# APPENDIX A MAJOR HAZARD FACILITIES UNIT MEETING NOTES

Minutes of: Major Hazard Facility Unit – 2024 briefing

Subject: Sumitomo Hydrogen Project

# **Close-out of MHFU Recommendation**

## Hydrogen release vent

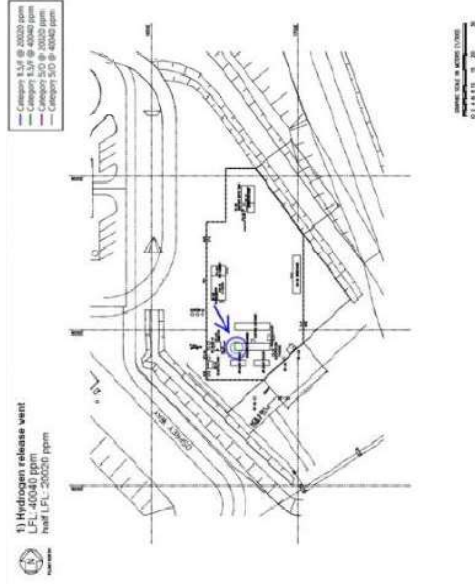
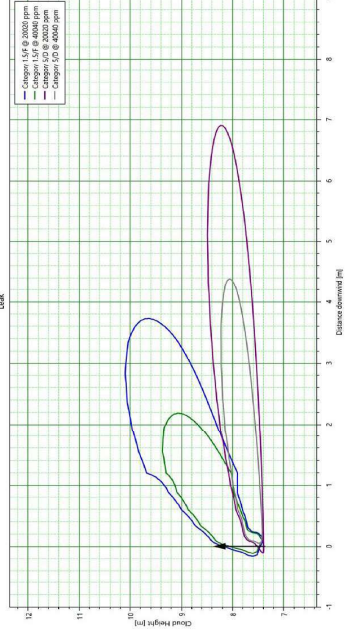
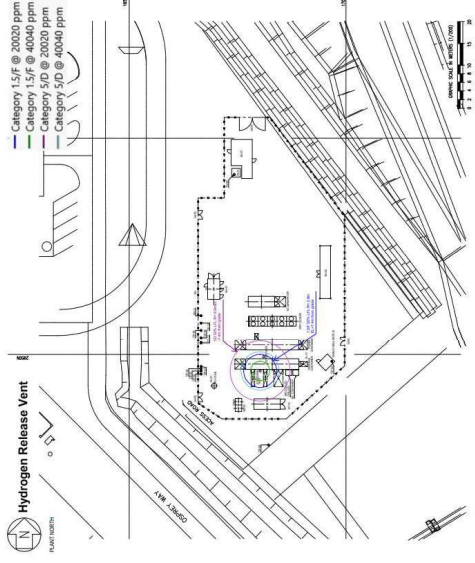
There shall not be allowed to locate any equipment and building within a radius of 3.7 m from the vent, 1 m height below the vent and 4 m height above the vent, that is 20020 ppm hydrogen dispersed area.

Dispersion radius increased but vent height increased to maintain safety

No equipment or buildings within the 50% LFL contour (20020 ppm) which is located:

- Within radius of 6.9 m from the vent
- 7.36 m height above grade

# Updated atmospheric vent dispersion study Oxygen release vent

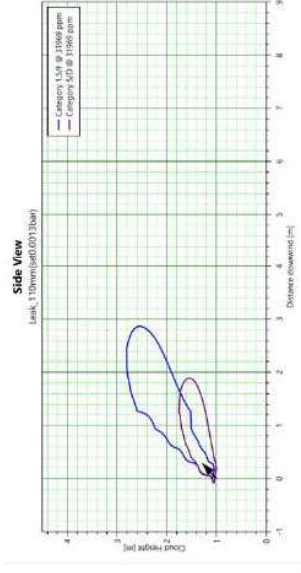
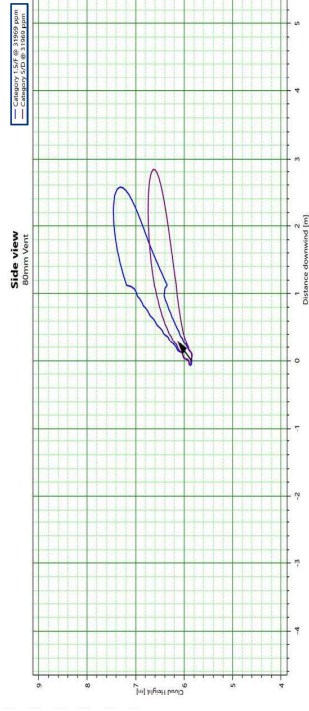
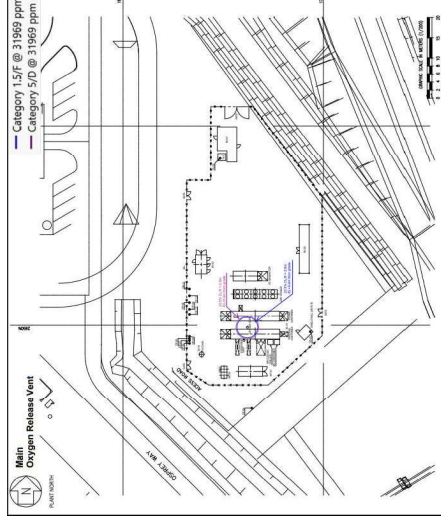
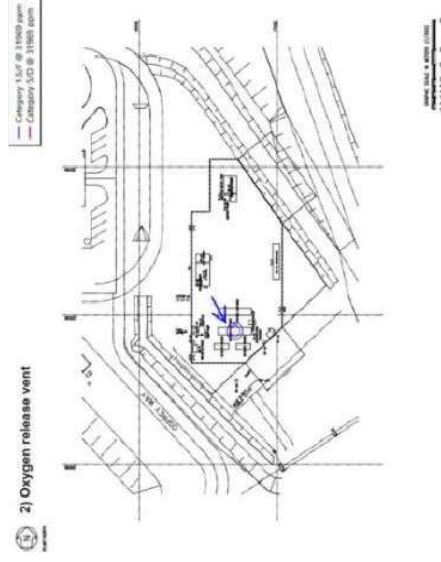
There shall not be allowed operator to access within a radius of 2.9 m from the vent, 1 m height below the vent and 2.9 m height above the vent, that is 31969 ppm oxygen dispersed area, where oxygen concentration is 23.5%.

Dispersion radius increased but vent height increased to maintain safety

No operator access within 23.5% O<sub>2</sub> concentration:

- Within radius of 2.9 m from the vent
- 7.5 m height above grade
- 5.9 m height above grade

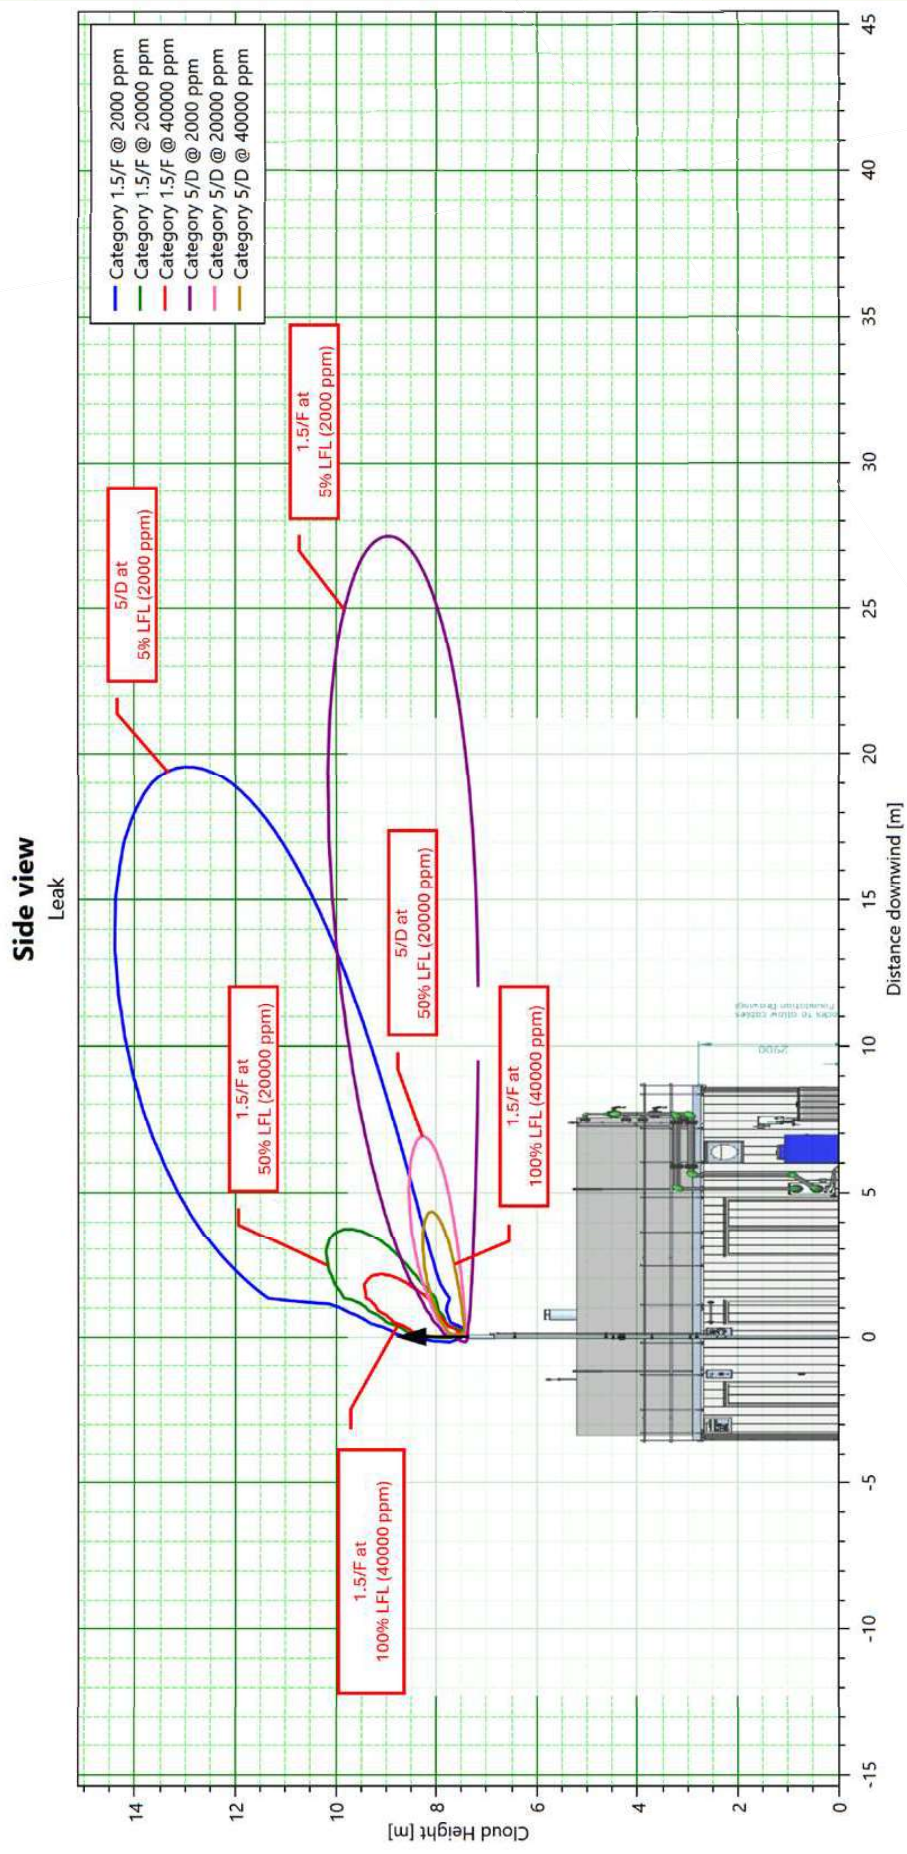
- ▶ ***“Cold hydrogen vents igniting due to static electricity. Consider static electricity sources in detailed design including site electrical facilities and thunderstorms associated with tropical storms and cyclones.”***

- Earthing and bonding controls have been incorporated into the design in accordance with applicable law, regulation and Australian Standard
- No equipment or personnel access will be allowed within the 50% LFL contour of the H2 release vent  
*MHFU commented, during preliminary discussion, that safe design considers 5% LFL for hydrogen release*

□ Provided below is the LFL, 1/2 LFL and 5% LFL contours from hydrogen release in the H2 vent

It has been demonstrated, through the simulation of H2 release from the vent, that the gas cloud at 5% LFL, is not touching any platform or area that is accessible to the operators.
